PREVOST

**SAFETY
RECALL**

SR23-43

DATE :	January 2024	SECTION :	23 ACCESSORIES
SUBJECT:	PREVOST DRIVER ASSIST – VERIFICATION OF ACB RADAR SENSOR FRONT BUMPER TRIM

Figure 1: VEHICLE EQUIPPED WITH ACB RADAR SENSOR

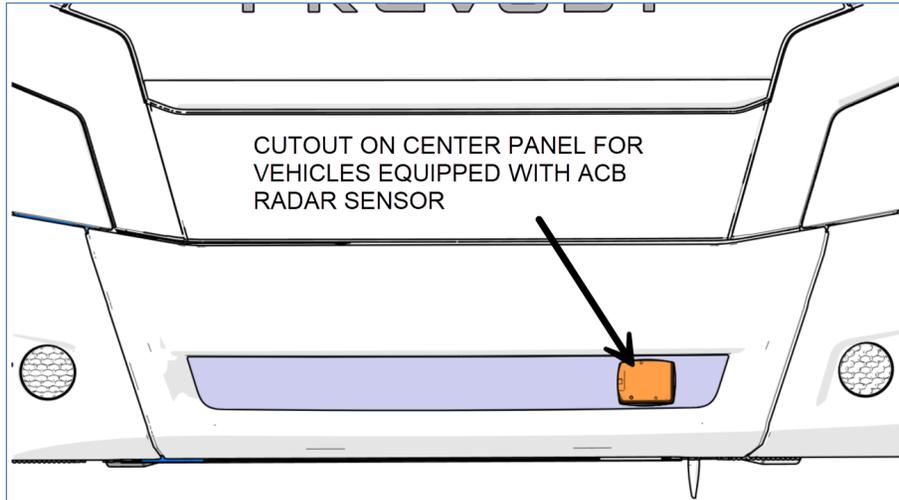
1. Vehicles equipped with the ACB radar sensor should have a cutout on the front bumper trim as seen on the image below.

Figure 2: VEHICLE EQUIPPED WITH ACB RADAR SENSOR

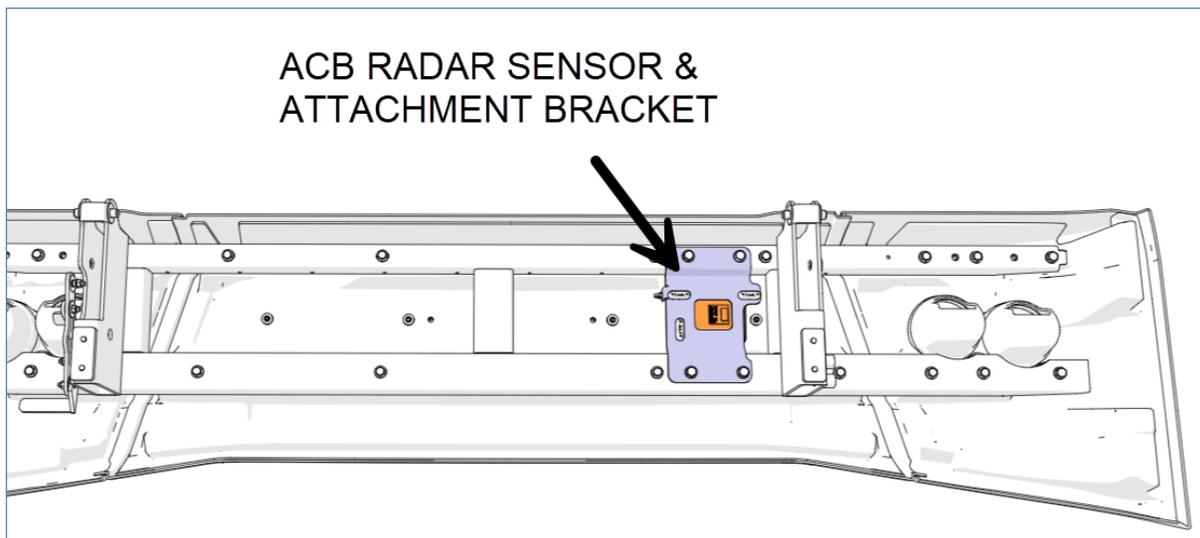
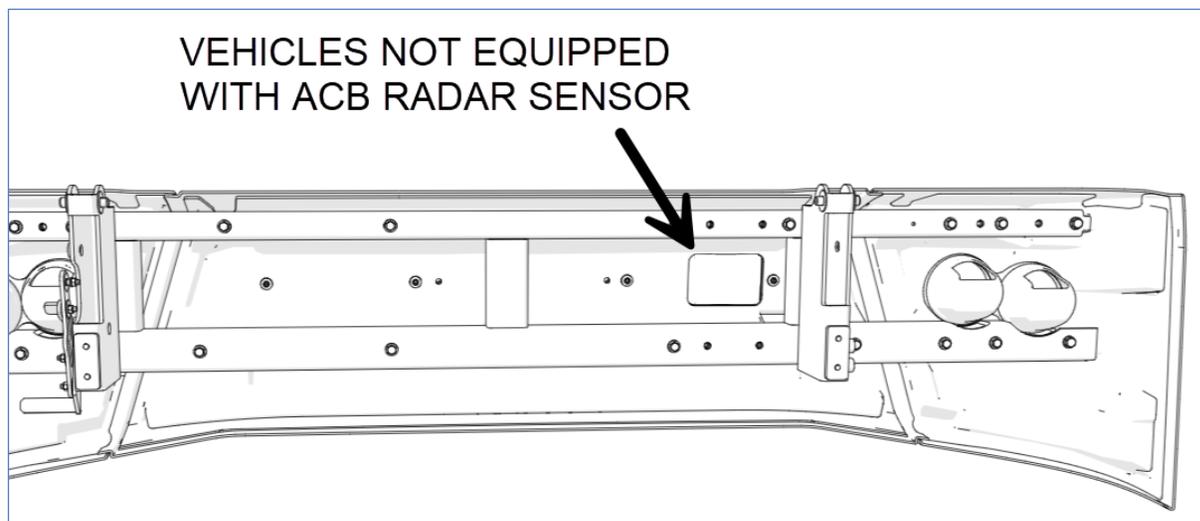
2. Open the reclining bumper. Confirm your vehicle is equipped with the ACB radar sensor.

3. If the front bumper trim installed on your vehicle **is** the appropriate one, no further steps are required. This completes the bulletin.
4. If the front bumper trim installed on your vehicle **is not** the appropriate one, perform PART 2 - FRONT BUMPER TRIM REPLACEMENT.

Figure 4

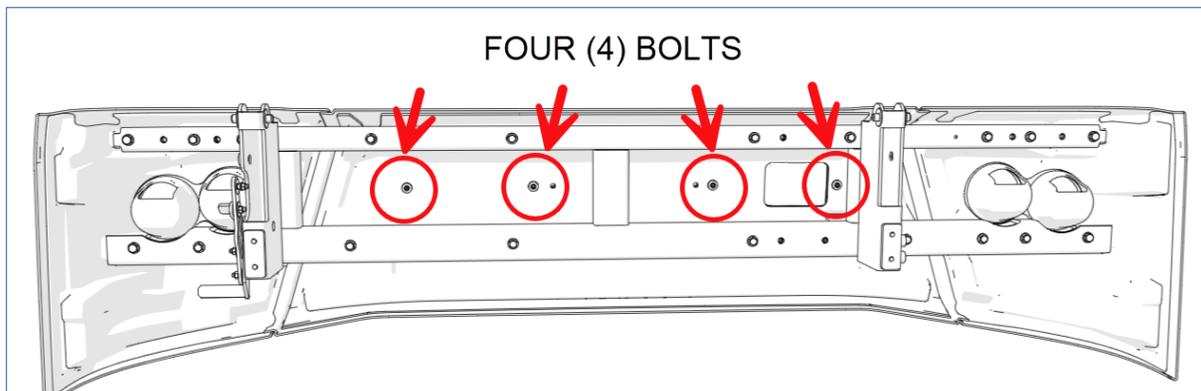
2. Remove the existing bumper trim. To do so, using a 10 mm hex socket, unscrew the four (4) bolts identified on the following image. Keep bolts and washers for reinstallation. Return incorrect bumper trim to Prevost.

3. Install the new bumper trim similarly.
